# DETAILED CONSERVATION COMMISSION AGENDA

Date: Thursday, January 27, 2022

### 1. (7:00) 152 Suffolk Rd – NOI – backyard pool, sports court, patio, and greenhouse – DEP #239-911

**5. (8:15) Hammond Pond Parkway – NOI – roadway and corridor improvement -- DEP #239-???**

LANDSCAPE PLANS 5  
NOTICE OF INTENT PLAN SET

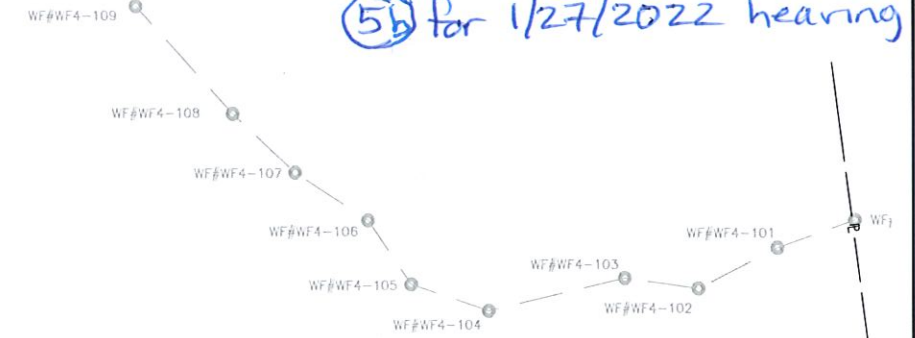
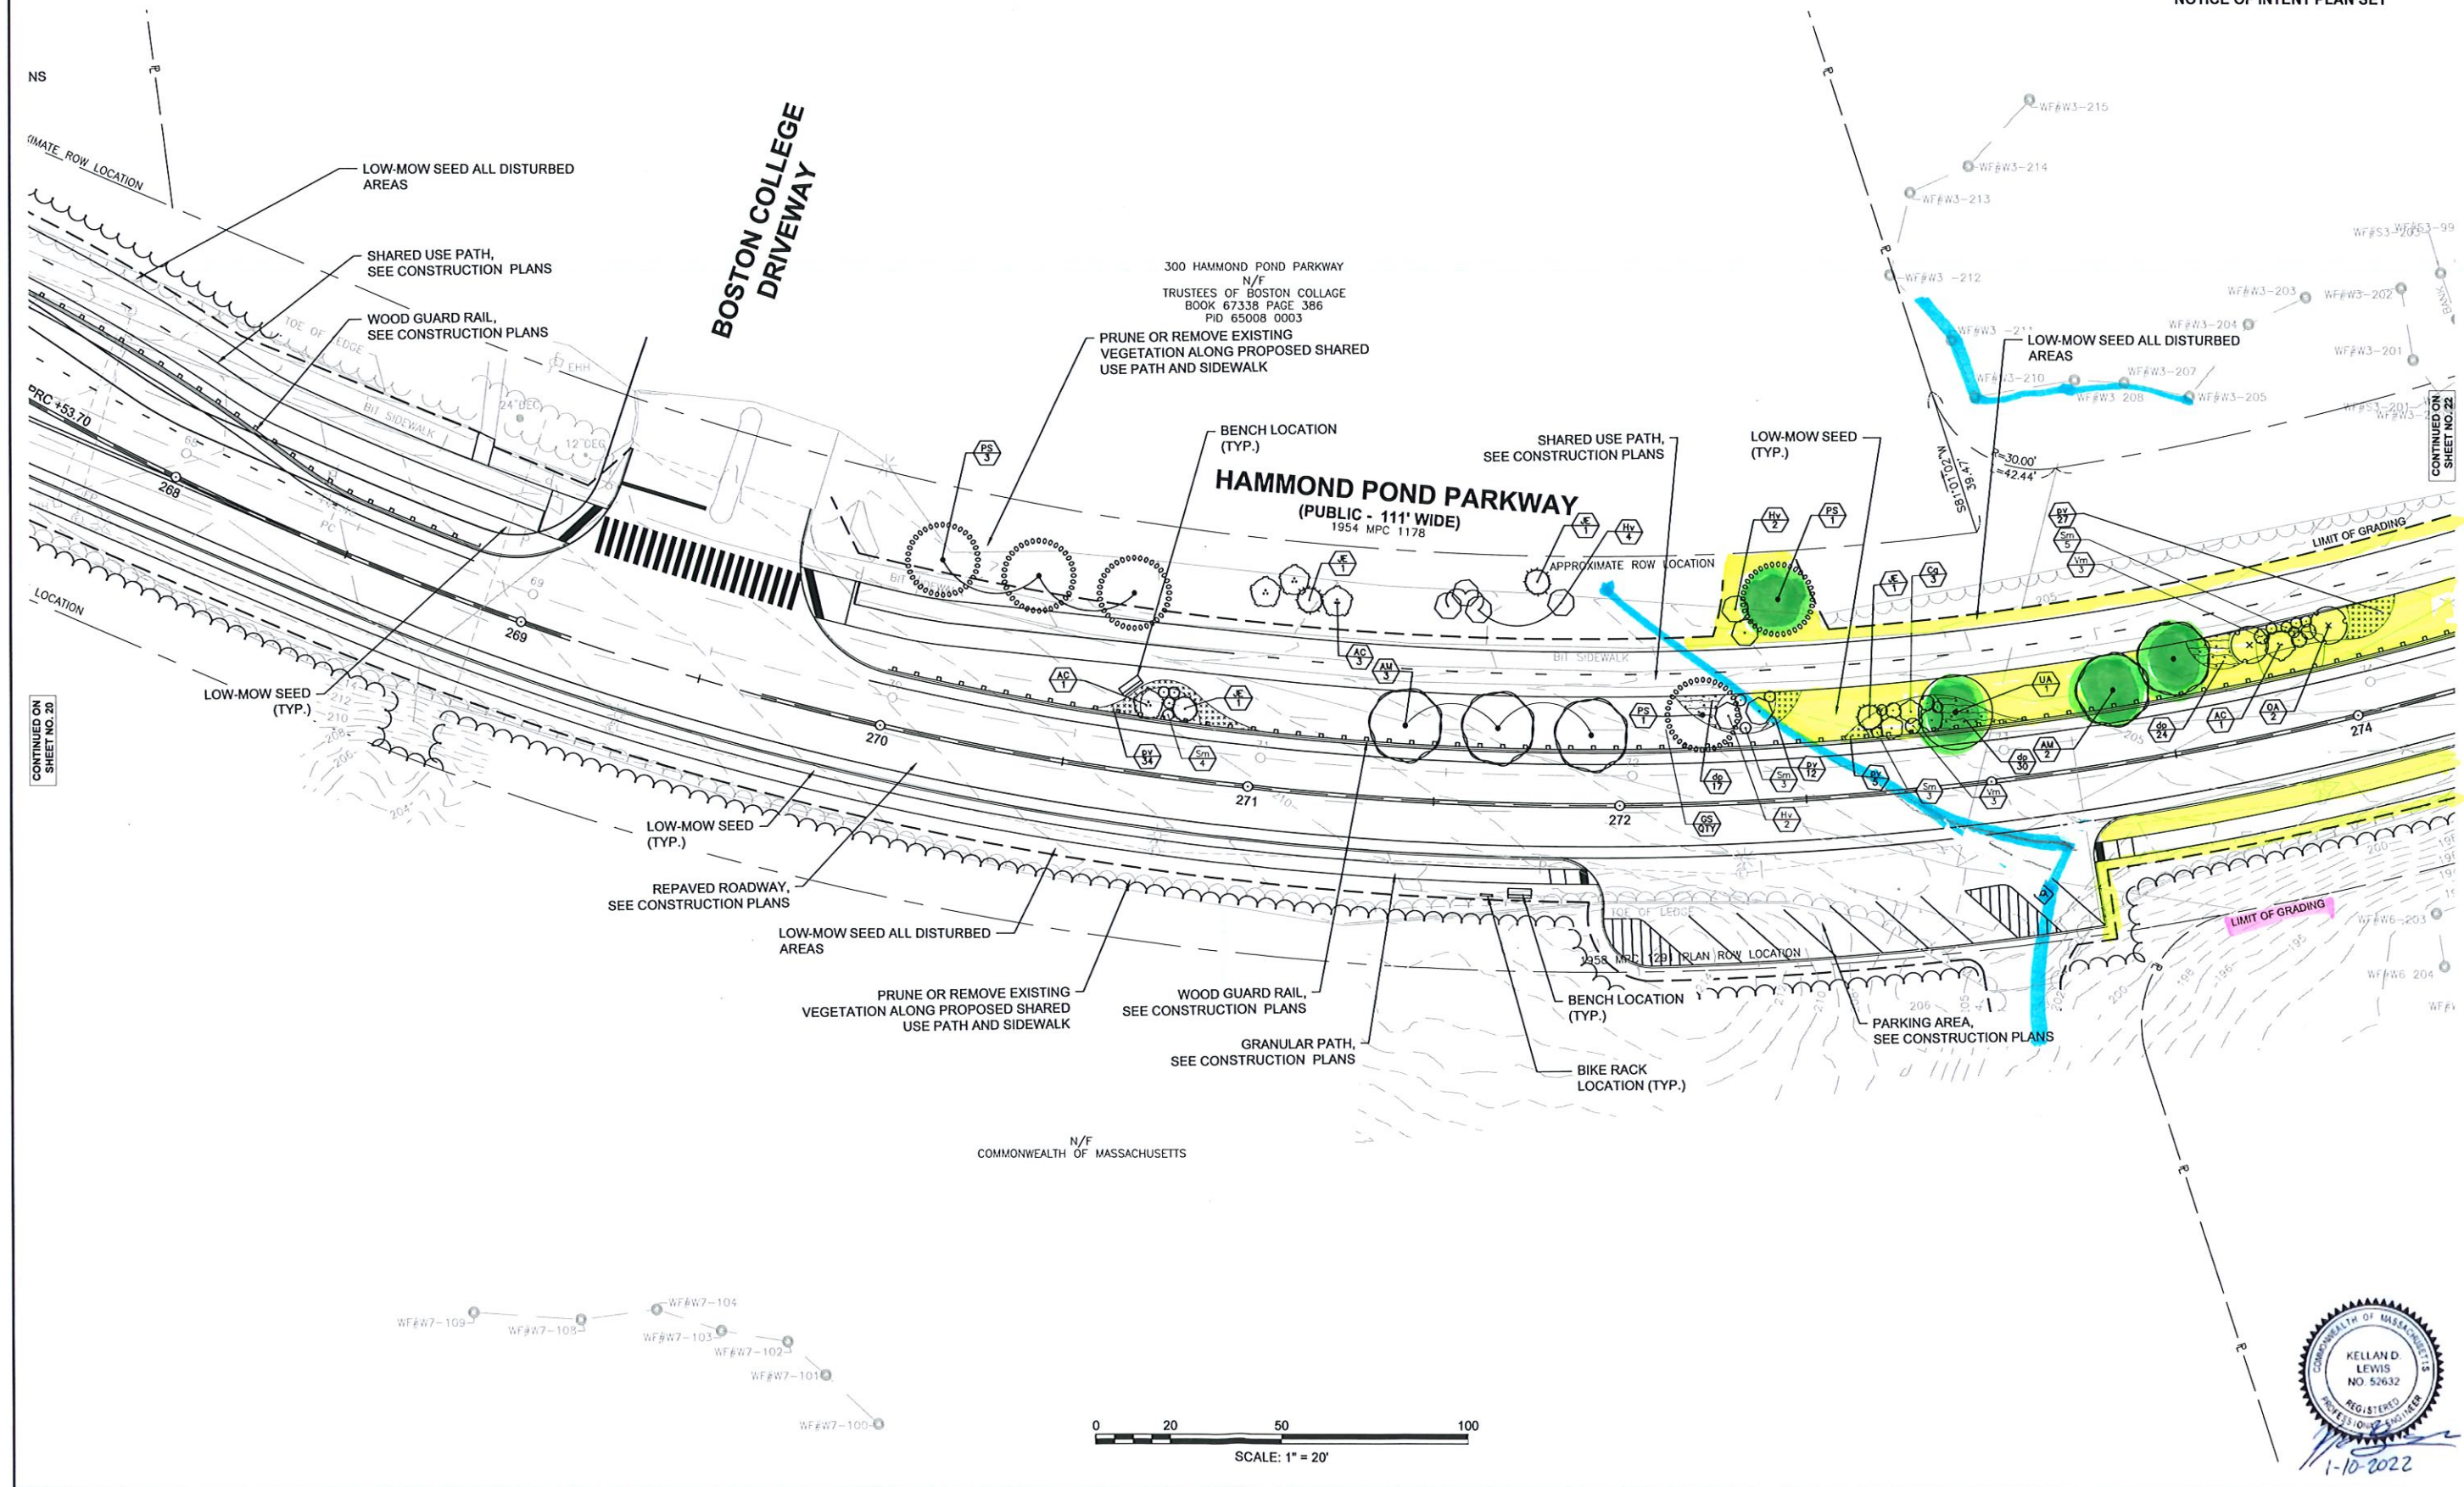
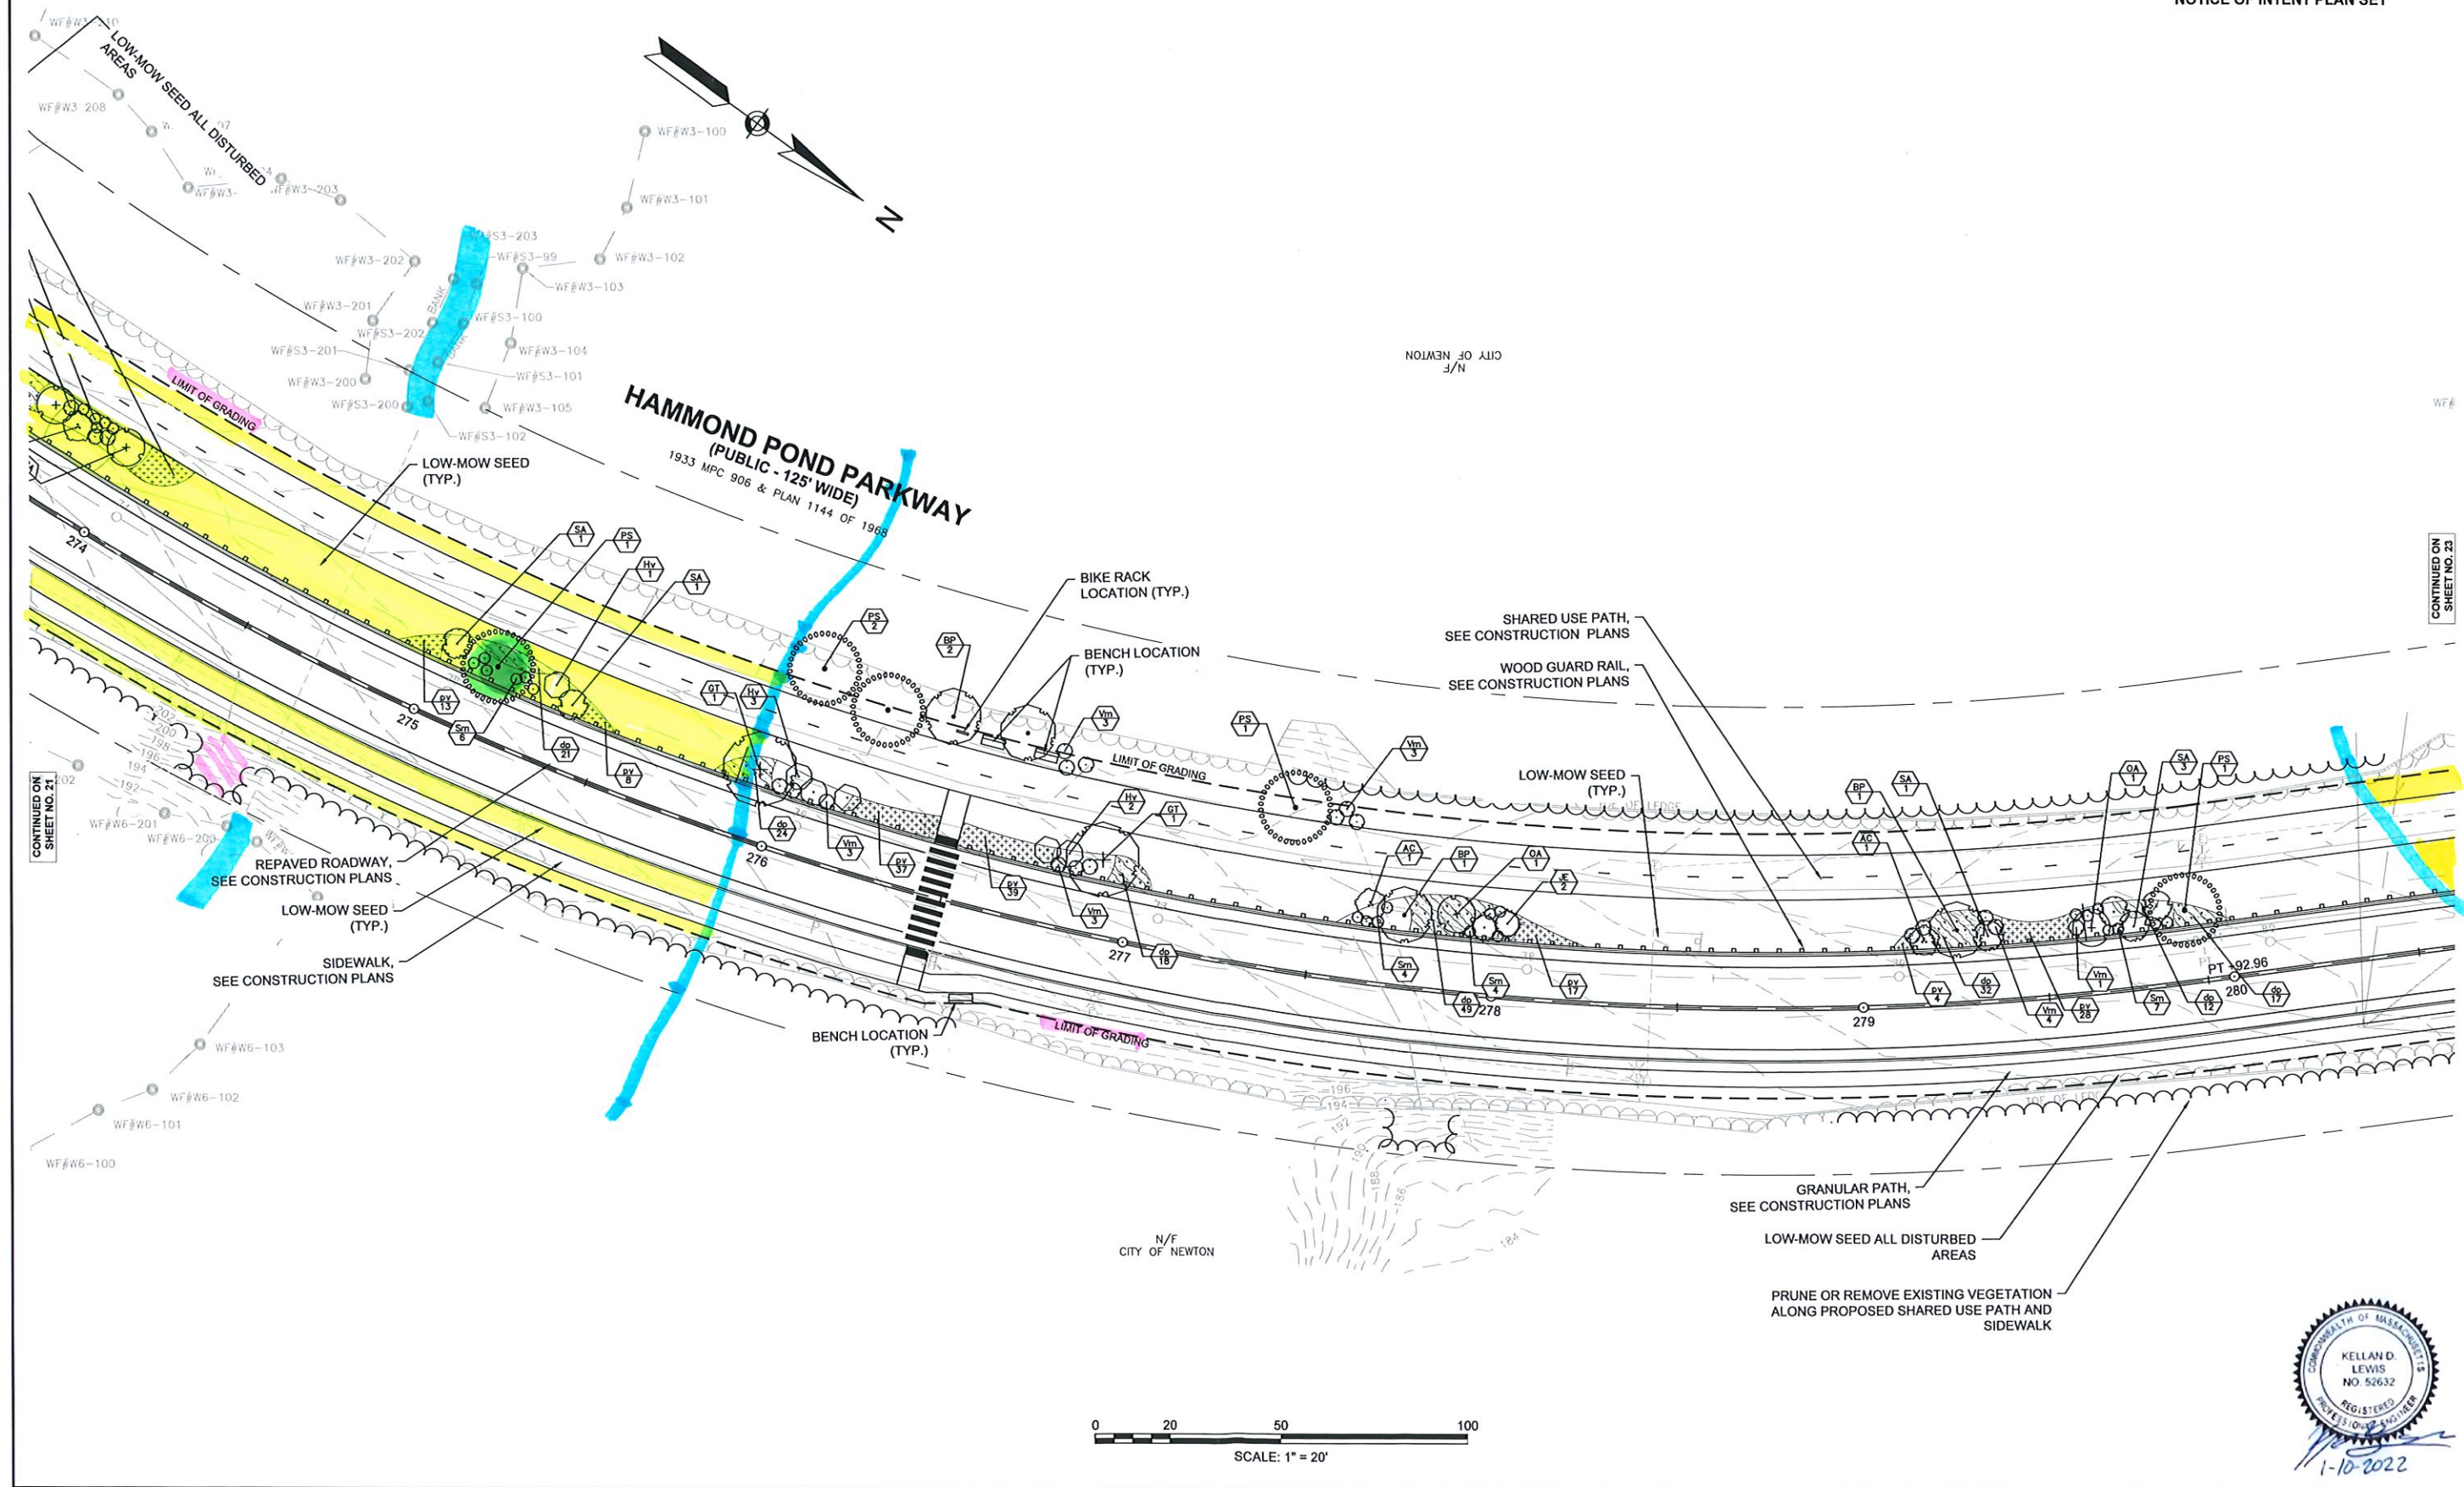
- There will be significant grading at the northeast corner of the new parking area, yet no new grade lines are shown and it appears that insufficient space is provided for side slopes. How will this area be addressed?
- On Landscape Plan sheet 5 there is a “limit of grading” label that appears to be on the property line. It should be removed.
- There is no erosion control/limit of work shown that would protect the “island of trees” near Hammond Brook. That should be added.
- Will there be any invasive control efforts?
